## The latest planning applications at Cairngorm (2) – mountain bike trails and infrastructure

This post considers Cairngorm Mountain Scotland Ltd (CMSL)'s second planning application at Cairn Gorm, to create new mountain bike trails in lower Coire Cas. The application ([see here for planning papers](#)), as I will explain, is as poorly documented and thought through as the first, which was to create two new roads on the mountain ([see here](#)).

Mid-section showing the “Advanced Descent” Trail 07 (or should that be 007?). Note the proposed location of the snow factory and access road, which will presumably be subject of yet another planning application, and also the two pits to be excavated for trail construction material

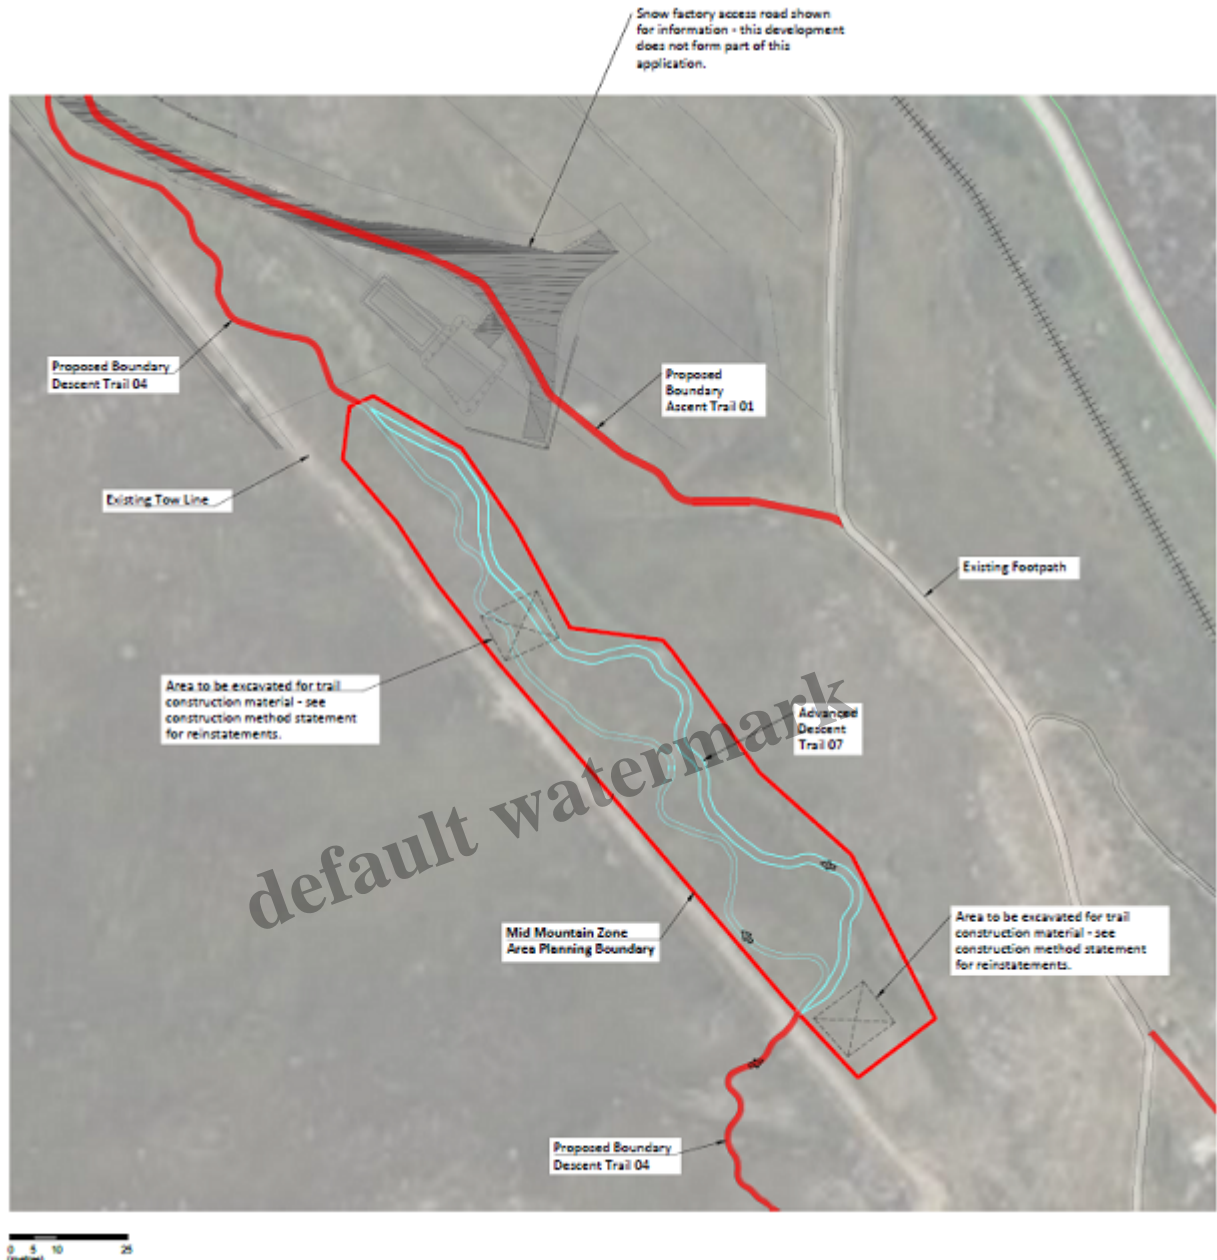
- there is no clear explanation of how the tracks will fit with existing snowsports infrastructure and the implications for this (indeed the primary purpose of the conveyor belt in the “learning zone” would appear to be for snowsports but there is no reference to that in the application);
- there is no explanation of the purpose or concept behind the “Ascent Trail” and why it has been split in Ascent Trail 1, 2 and 3 when it all appears part of the same route;
- there is no key to the colour coding used for the “Descent Trails” although it appears (but see below) to go brown, red, blue in ascending order of difficulty;
- if this interpretation is correct, someone wanting to cycle the “medium difficulty” red trail to the shieling and then back down could then get stranded as the two trails down the mid-zone are both blue and one is labelled as “Advanced Descent 07”;

How the inclusion of an “Advanced Descent Trail” fits with the overall concept which is for a beginners’ mountain bike park, is not explained;

The proposal is to add a mountain bike path along the upper side of this road. Photo August 2017

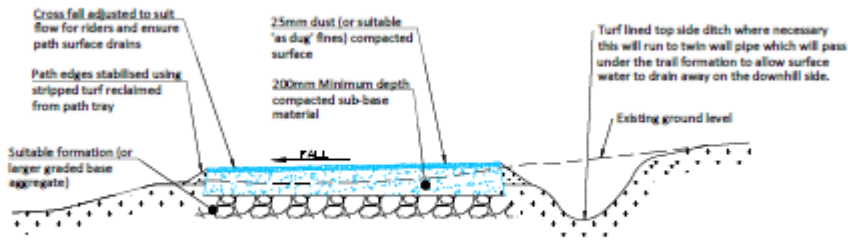
The proposal is that the top section of the ascent trail runs along the road up into Coire Cas the

landscape impact of which I considered in [The Cairngorms through the lens of Adam Watson \(3\) – Coire Cas, the long view](#). In effect CMSL is proposing to widen that road, which will increase its visual impact in summer.

**Typical Trail Construction Detail**

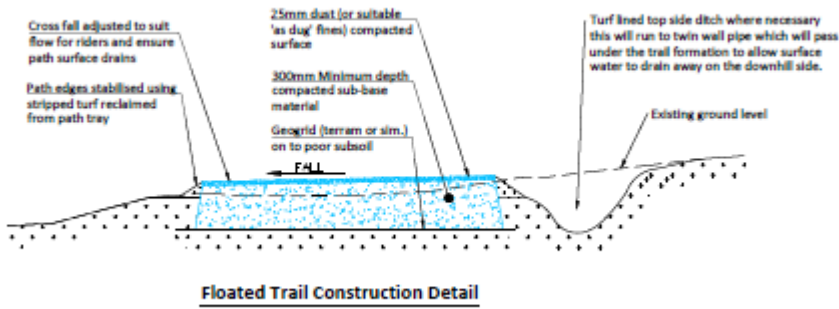
Just why a new mountain track is needed here, when vehicles on the mountain are supposed to be kept to the minimum, or what it will add to the biking experience is not explained. The section diagrams for the track don't even explain its width:

At the very least it appears the footprint of the road, if this development was allowed to go ahead, would be widened by a further 2m, making it even more visible. Not what the National Park should be about.

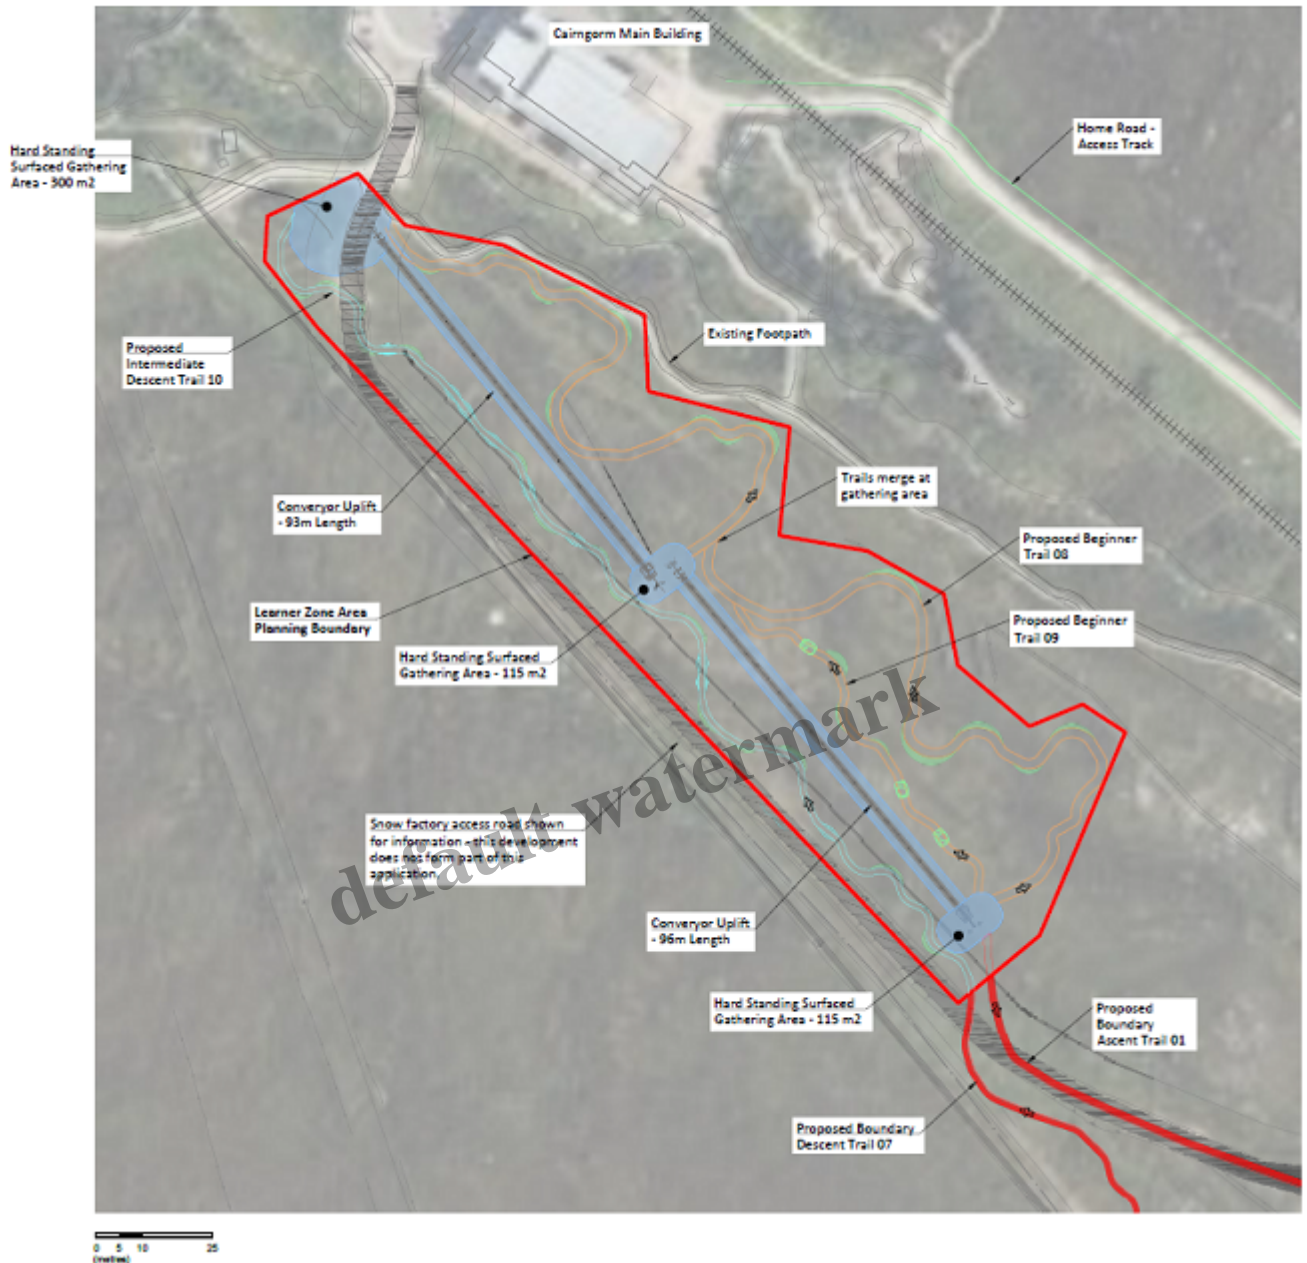
In this plan the blue marks an “intermediate” trail whereas in the mid-section above blue means “advanced”! There is no key to the black shaded line which one might guess was a road but you will note that near the bottom of the map there are two parallel lines that run alongside it which are marked “snow factory road”.

There will be two conveyor belts – which as I have pointed out before should not be needed for bikes – with areas of hard standing at the top and bottom of each. Alongside the conveyor belt will be a new access road to the re-located snow factory, which CMSL says is not part of this application. It should be! The further development of this bit of ground by the Day Lodge should be considered as a whole, not piecemeal.
